Built Heritage Sub-Committee / Sous-comité du patrimoine bâti
April 13, 2017 / 13 avril 2017

File Number: ACS2017-PIE-RHU-0003

SUBJECT: Application to Alter the Somerset House, 352 Somerset Street West, a property designated under Part V of the *Ontario Heritage Act* and located in the Centretown Heritage Conservation District

Document 5 – Elevations

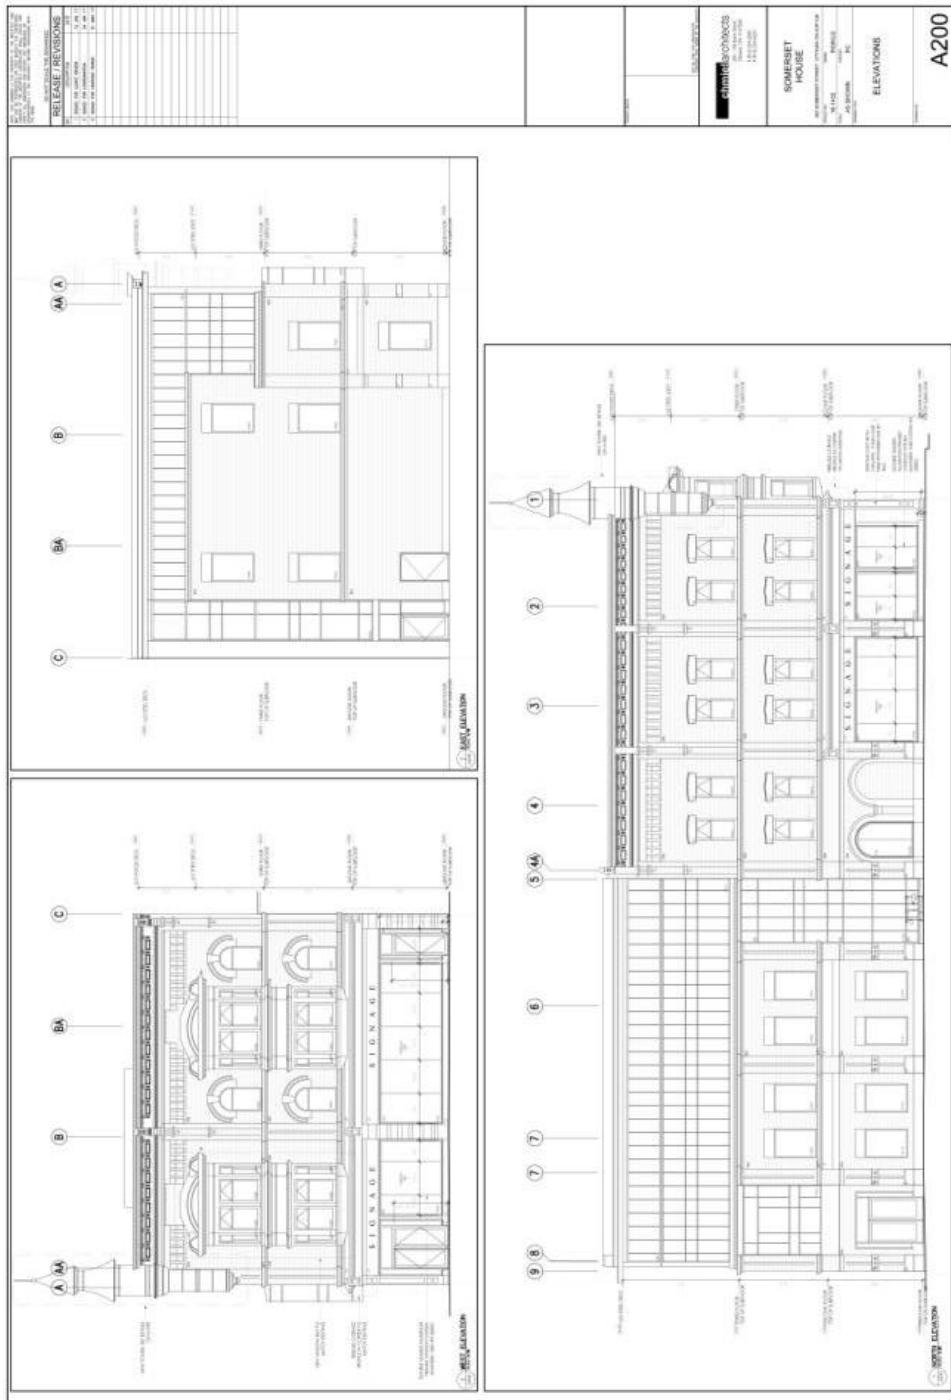
I do have some reservation regarding the cornice. It appears on the renderings that the rear portion of the building is ornamented with a remarkably different style of cornice. This inconsistency would be apparent from Bank St., as well as from Somerset St. and would contribute to the discontinuity between both parts of the building.

Document 6 – Restoration Details

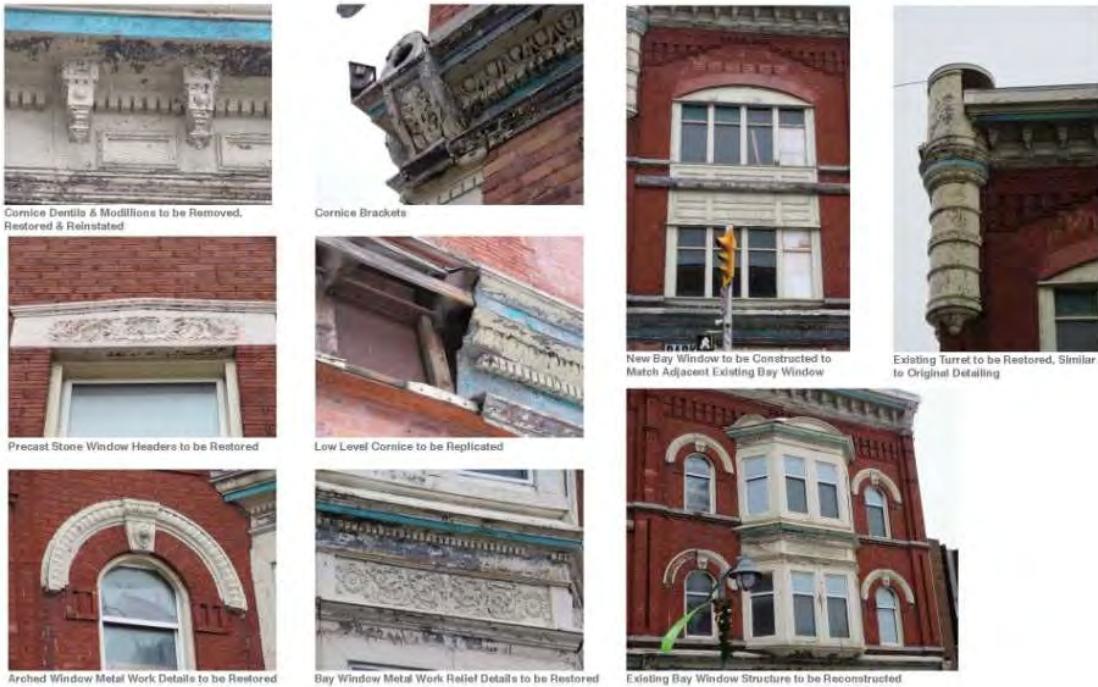
1. We are very encouraged by the plans for restoring the original heritage section and support the proposal for this part of the building. In particular, the proposal to restore the original corner tower is exemplary. Also of note are the plans to restore the metalwork and cornice. Overall, we are very pleased with the plans for restoring the existing portion of the heritage structure.
